PART OF LOT 1
CONCESSION 9
CITY OF CAMBRIDGE
REGIONAL MUNICIPALITY OF WATERLOO
REGISTERED PLAN

BARLASSINA CONSTRUCTION INC.

PROJ. No. 21-35

LOT No. 65

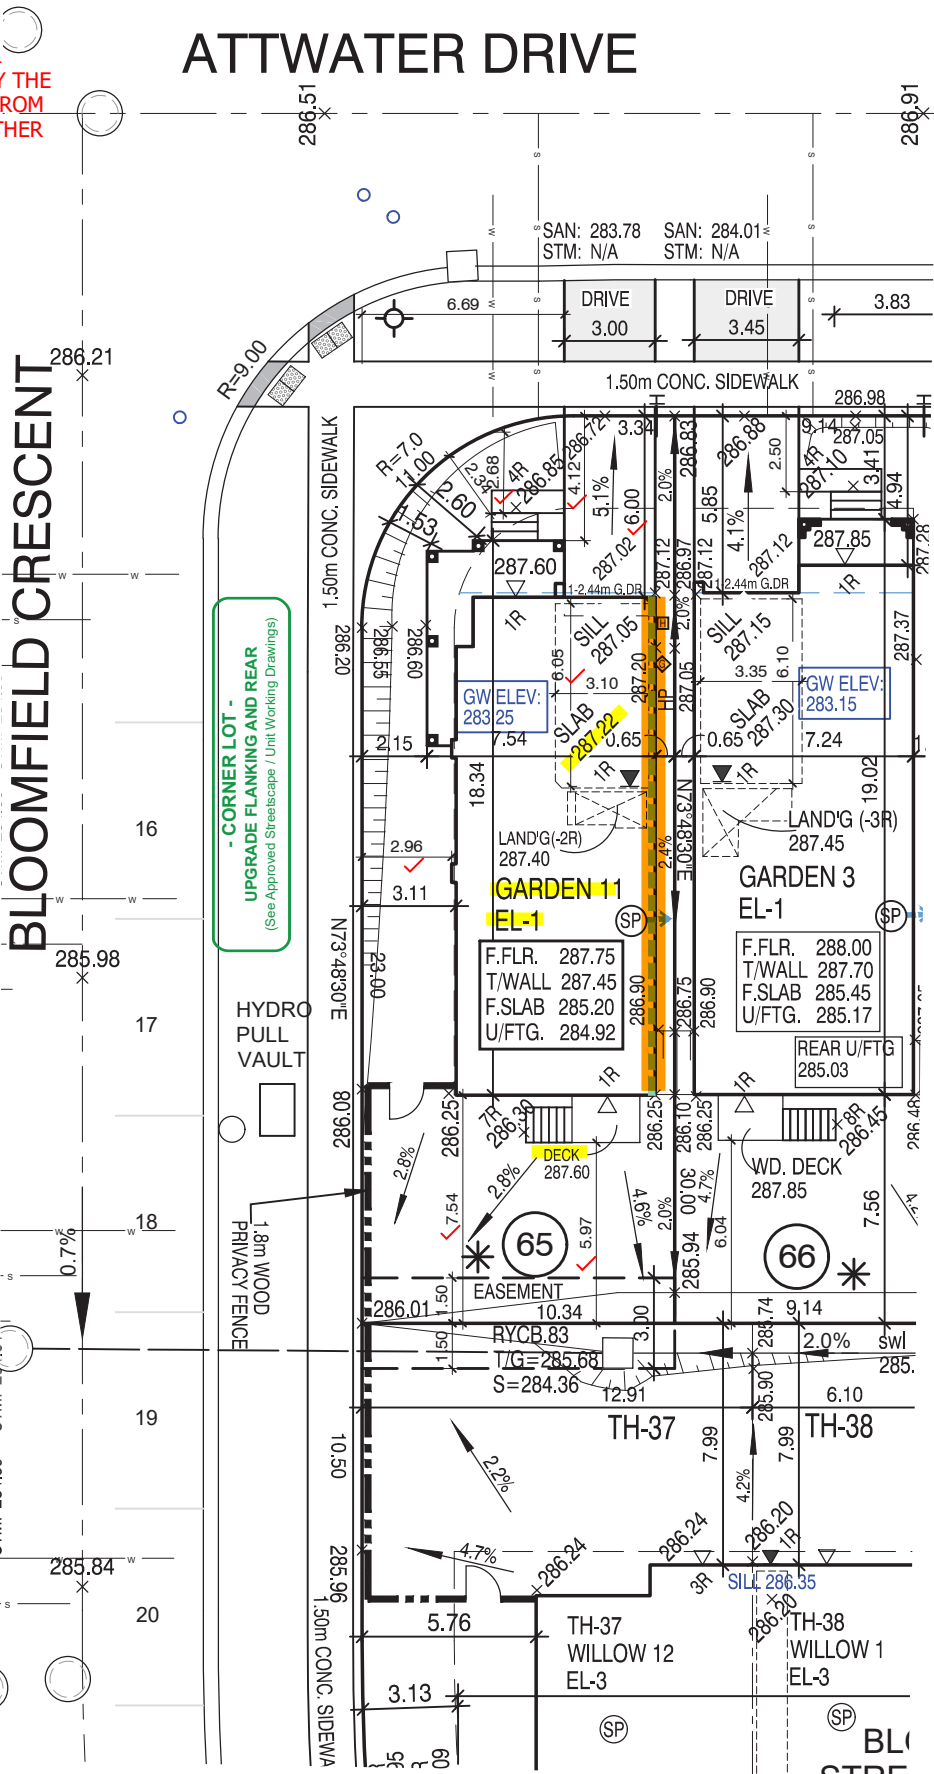
P.ENG SOILS REPORT IS REQ'D TO CONFIRM BEARING CAPACITY OF SOILS. SEE FIELD INSPECTOR

CERTIFICATE OF U/S OF FOOTING ELEVATION AND P.ENG SOILS REPORT REQ'D AT FOOTING INSPECTION (see inspector)

MIN. 4' FROST PROTECTION FOR ALL FOOTINGS

PLAN IS REVERSED FROM APPROVED MASTER DRAWING

Clear stone must be used when the building separation on side yards is 1.5m or less, and must be inspected by the City prior to the placement of stone. The depth of the clear stone shall not be less than 150mm and placed on the geotextile membrane.

45 MINUTE RATED WALL
WITH SIDE YARD < 1.2m
